KOREA AUTOMOBILE TESTING & RESEARCH INSTITUTE

GTR 13 Phase 2 9th IWG meeting-TF1

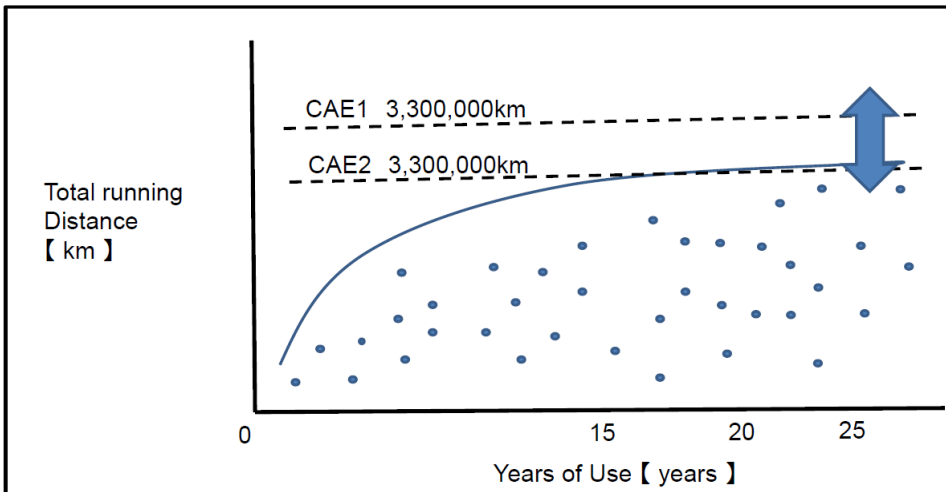
- Proposal to separate requirement for LDV vs HDV (towards emergency exits would apply for HDV only).

JAMA suggests the language of “towards emergency exits” would apply for **Category 1-2 only**.

- The hydrogen gas discharge from TPRD(s) of the storage system shall not be directed towards any exit(s).
